NOTICE TO BIDDERS
ADDENDUM #2
TOWNSHIP OF RANDOLPH, MORRIS COUNTY, NEW JERSEY
CALAIS ROAD PARK
BID OPENING DATE – JUNE 29, 2018, 11:00 A.M.

SHEET 3 - ADDENDUM 2
 FOR
CALAIS ROAD PARK
LOTS 2 & 3 BLOCK 49
 TOWNSHIP OF RANDOLPH
 MORRIS COUNTY NEW JERSEY

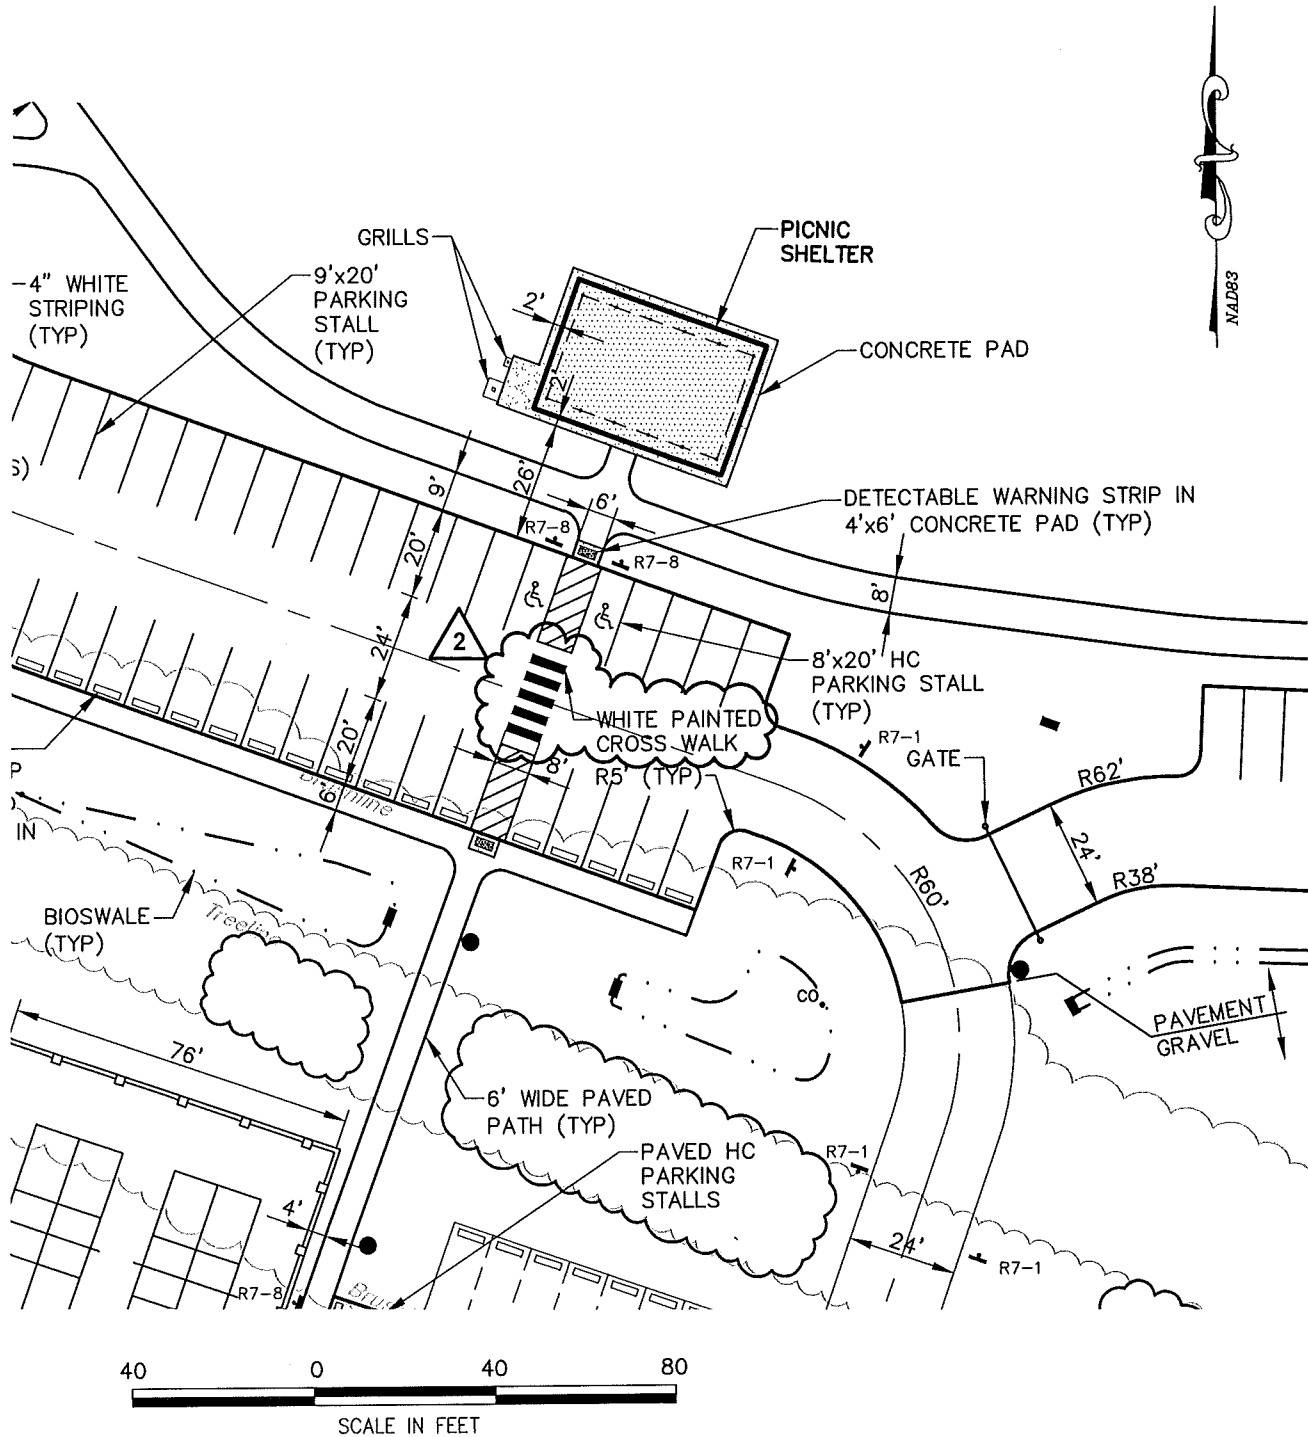
There is a crosswalk that should have been included on the plans. The attached is an addendum to Sheet 3 of the project drawings.
